September 18, 2023

Mr. Darren Nielsen
Vice President/KC Studio Leader
HNTB
715 Kirk Drive
Kansas City, MO 64105

Subject: Ryan Field Redevelopment at Northwestern University
Rebuttal to Arup report

Figure 5: Short Duration Sound Measurement
Locations October 8, 2022

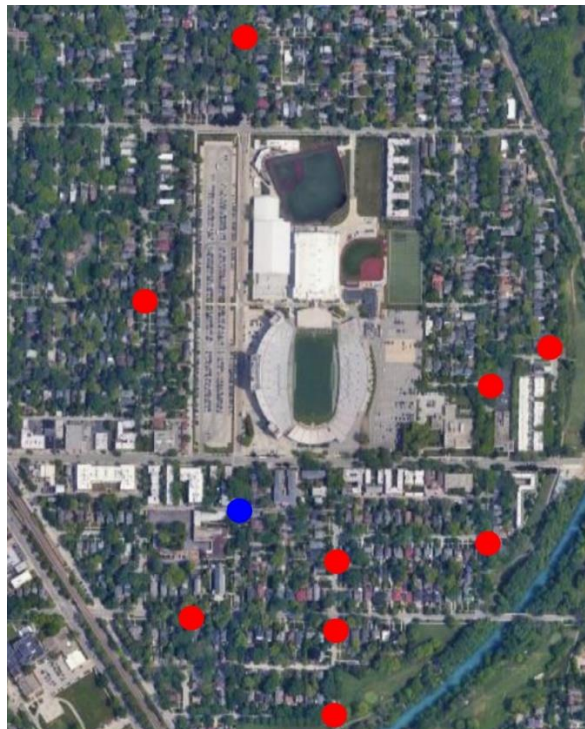
Item 5	
Document	WJHW letter 1, Henderson Exhibit, page 4
	Gameday measurements in neighborhoods were short-duration 30-120s at each location. This measurement duration may be too short to represent gameday activity sound levels.
Arup Comment	Measurements of existing gameday sound in surrounding community should capture range of gameday activity sound (crowd cheers, public address announcements, etc.). Document the gameday activities occurring during measurement intervals. Conduct longer or multiple measurements at each location as required to capture typical range of gameday activity levels.
WJHW Response	Short duration measurements were collected during the gameday noise study. All measurements included activity noise from the stadium which was primarily public address announcements and fan noise.

Item 6	
Document	WJHW letter 1, Henderson Exhibit, pages 4-5
	Only one gameday measurement (30-120 seconds in duration) was conducted in Wilmette. Results for gameday measurements are presented as an aggregate range with no results at individual receptors presented.
Arup Comment	Provide a supplementary gameday activity sound survey which includes additional neighborhoods to provide better representation of impacted areas. Include measurement results for each receiver location.
WJHW Response	Measurements were conducted in neighborhoods with close proximity to the stadium and are representative of those areas which may have the greatest impact from stadium activities.

- 3) The LAeq sound levels ranged from 50-65 dBA for the locations shown in red. The LAeq sound level at the blue location was 84 dBA primarily due to the large party at the south end of west parking lot shown in Figure 4.

- 4) The primary noise source from the football stadium was the sound system, and it was audible at all of the short duration sound measurement locations. Since this is not a consistent noise source, it is not possible to isolate that sound from the other ambient noise such as cars, people, trains, and birds.
